SIB 21 01 22

CLUTCH NOISES WHEN DRIVING OFF FROM A STANDSTILL

2022-05-26

Figure 1: Oil Pipe (#1 in picture)

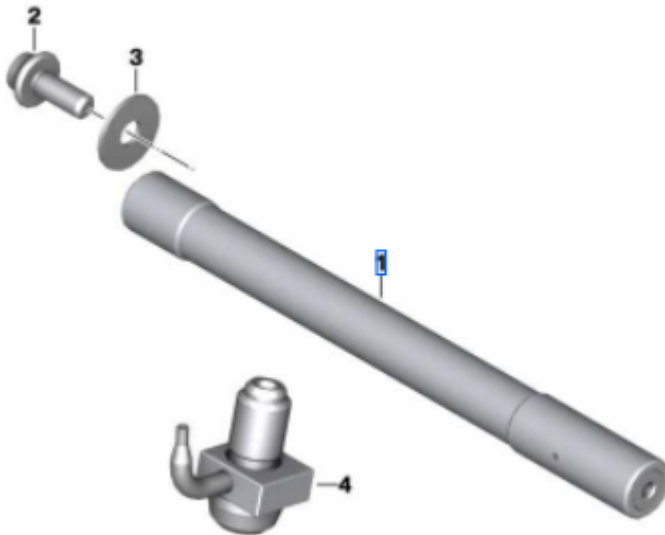
In the clutch friction phase when driving off, the clutch makes squeaking noises.

A modified oil pipe which increases the oil supply to the clutch, part number below, must only be installed in the event of a noise complaint by a customer.

In case of such a complaint, inspect the clutch discs for damage and signs of overheating; if none are found, replace the oil pipe using the information below, reusing the clutch components.

If damage and signs of overheating are found, replace the oil pipe using the information below, and replace the clutch disc set, remembering to thoroughly oil it before installation.

NOTE: Because the new and old oil pipes differ only in their internal structure - there are no external distinguishing features – there is a risk of mixing them up. Mark the new oil pipe prior to the removal of the old oil pipe.

Figure 1: Oil Pipe (#1 in picture)

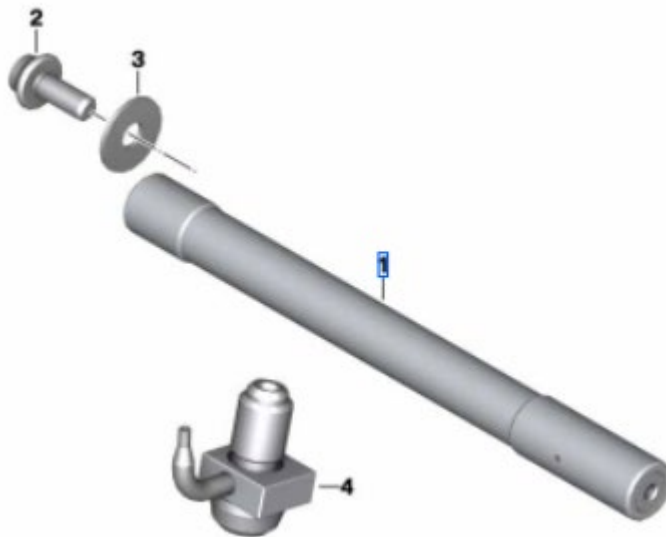
In the clutch friction phase when driving off, the clutch makes squeaking noises.

A modified oil pipe which increases the oil supply to the clutch, part number below, must only be installed in the event of a noise complaint by a customer.

In case of such a complaint, inspect the clutch discs for damage and signs of overheating; if none are found, replace the oil pipe using the information below, reusing the clutch components.

If damage and signs of overheating are found, replace the oil pipe using the information below, and replace the clutch disc set, remembering to thoroughly oil it before installation.

NOTE: Because the new and old oil pipes differ only in their internal structure - there are no external distinguishing features – there is a risk of mixing them up. Mark the new oil pipe prior to the removal of the old oil pipe.
